October 20, 2006

Dorena Goding
Division of Water Quality
State Water Resources Control Board
1001 I Street
Sacramento, CA 95814

Subject: Comment Letter – 2006 Federal CWA Section 303(d) List

FIGURE 12-2a
SITE 11 MUGU LAGOON
AND DRAINAGE DITCHES
SAMPLE LOCATIONS

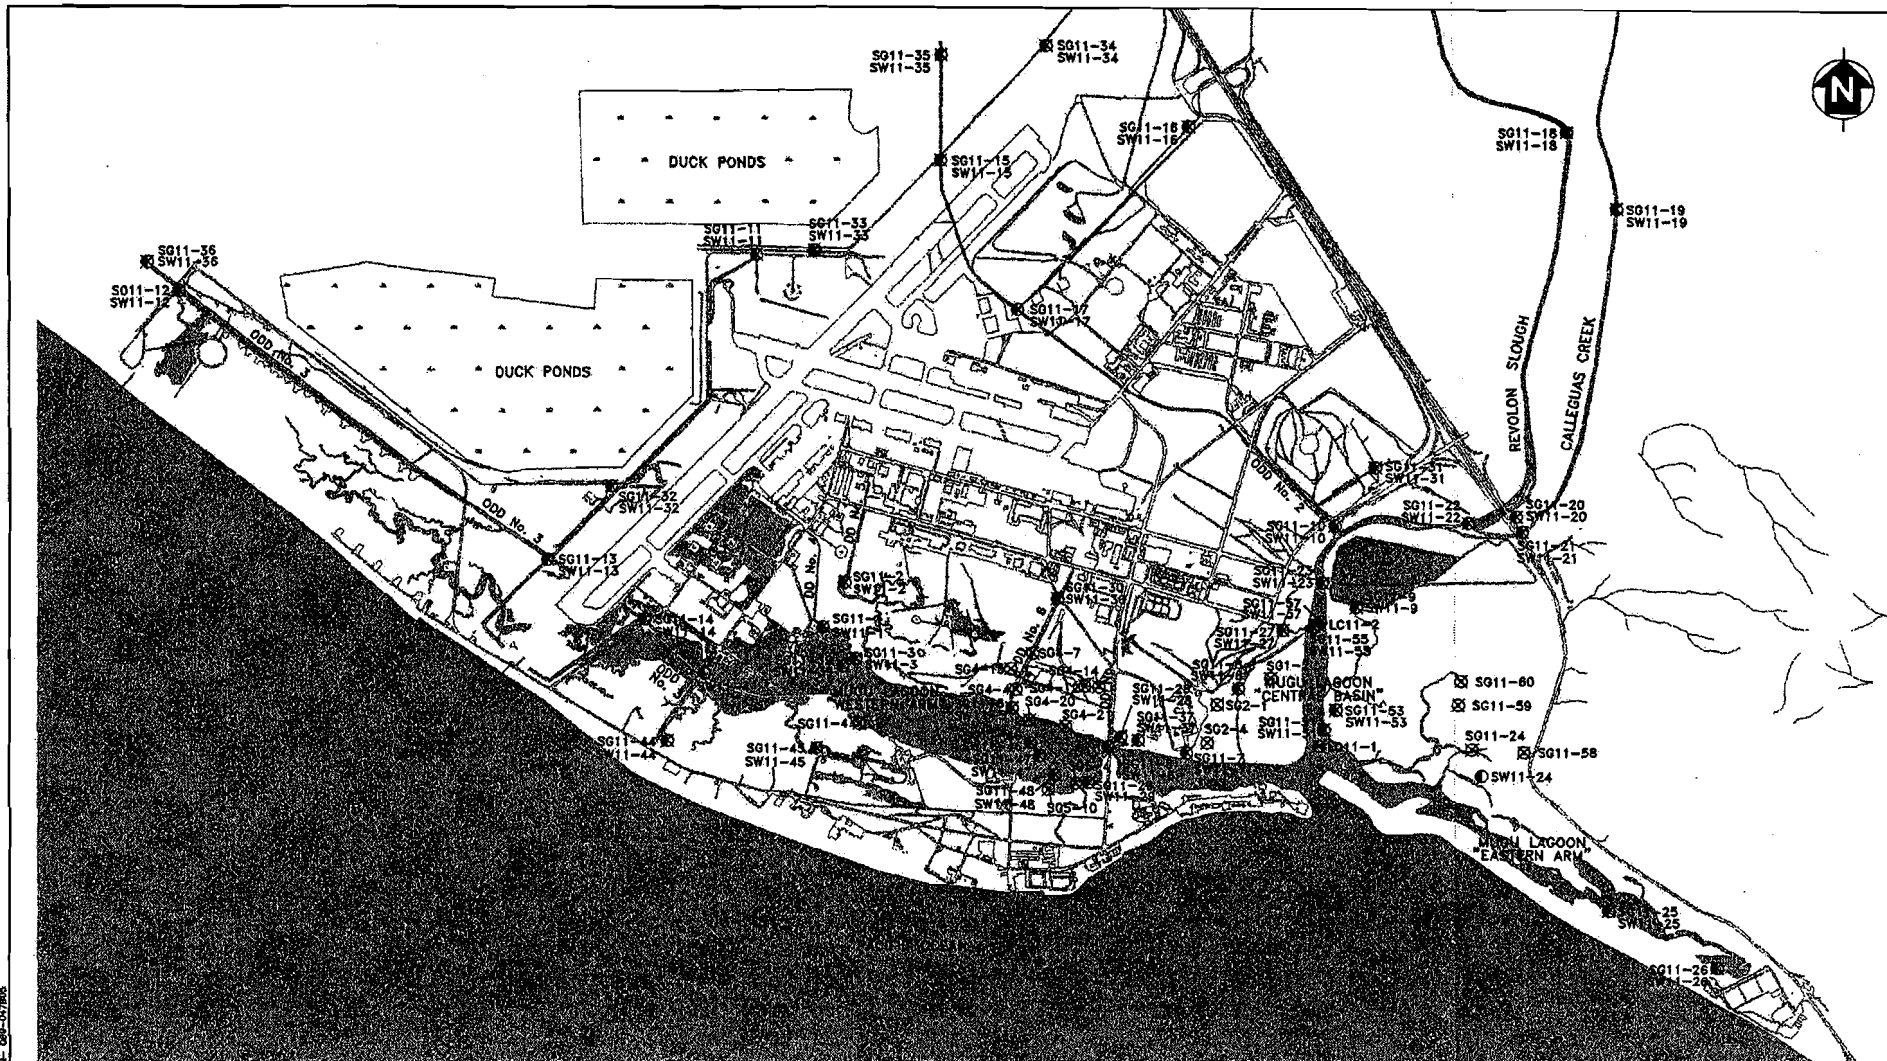
Reach	Monitoring Type	Project SiteID	Sample Source	Sample Date	Sign	Result (ug/L)	Exceed	Used in Analysis	Reason for Exclusion
NA	Navy	SW5-2	Drainage Ditch	1/27/94	<	6.8	0	No	The Phase 1 RI (pg 8-7) states these samples were collected to determine if surface water is transporting contaminants off site and toward Mugu Lagoon...., SW5-2, which is in a drainage channel that discharges to Mugu Lagoon. The Phase 1 RI indicates this sample was collected to characterize discharges to the lagoon and not the lagoon itself.
NA	Navy	SW5-2	Drainage Ditch	1/27/94	<	6.8	0	No	
NA	Navy	SW5-2	Drainage Ditch	1/27/94	<	6.8	0	No	
NA	Navy	SW5-2	Drainage Ditch	1/27/94	=	8.3	0	No	
NA	Navy	SW5-2	Drainage Ditch	1/27/94	=	9.9	0	No	
NA	Navy	SW5-2	Drainage Ditch	1/28/94	<	6.8	0	No	
NA	Navy	SW5-2	Drainage Ditch	1/28/94	<	6.8	0	No	
NA	Navy	SW5-2	Drainage Ditch	1/28/94	<	6.8	0	No	
NA	Navy	SW5-2	Drainage Ditch	2/3/94	<	5	0	No	
NA	Navy	SW11-28	Drainage Ditch	2/3/94	=	7.8	0	No	The Phase 1 RI (pg 12-7**) identifies this sampling location as a small drainage channel indicating it was established to characterize discharges to the lagoon and not the lagoon itself. Fig. 12-2a suggests this site corresponding to drainage ditch No. 7.

NA	Navy	SW11-30	Drainage Ditch	2/3/94	<	5.6	0	No	The Phase 1 RI (pg 12-7) identifies this sampling location as a small drainage channel indicating it was established to characterize discharges to the lagoon and not the lagoon itself. Fig. 12-2a suggests this site corresponds to drainage ditch No. 6.
NA	Navy	SW11-1	Drainage Ditch	1/25/94	<	7.7	0	No	The Phase 1 RI (pg 12-6) identifies this sampling location as being either a drainage ditch, storm sewer, or sewage treatment plant outfall indicating it was established to characterize discharges to the lagoon and not the lagoon itself. Fig. 12-2a suggests this site corresponds to drainage ditch No. 4.
NA	Navy	SW11-3	Drainage Ditch	1/25/94	<	7.4	0	No	The Phase 1 RI (pg 12-6) identifies these sampling locations as being either a drainage ditch, storm sewer, or sewage treatment plant outfall indicating they were established to characterize discharges to the lagoon and not the lagoon itself. Fig. 12-2a suggests these sites correspond to drainage ditch No. 5.

NA	Navy	SW11-2	Drainage Ditch	1/25/94	<	6.8	0	No	
NA	Navy	SW11-4	Drainage Ditch	1/31/94	<	6.8	0	No	The Phase 1 RI (pg 12-6) identifies this sampling locations as being either a drainage ditch, storm sewer, or sewage treatment plant outfall indicating it was established to characterize discharges to the lagoon and not the lagoon itself. Fig. 12-2a shows this site may correspond to Oxnard Drain No. 3.

**SW11-XX samples were taken at the same locations as SG11-XX. See Fig. 12-2a
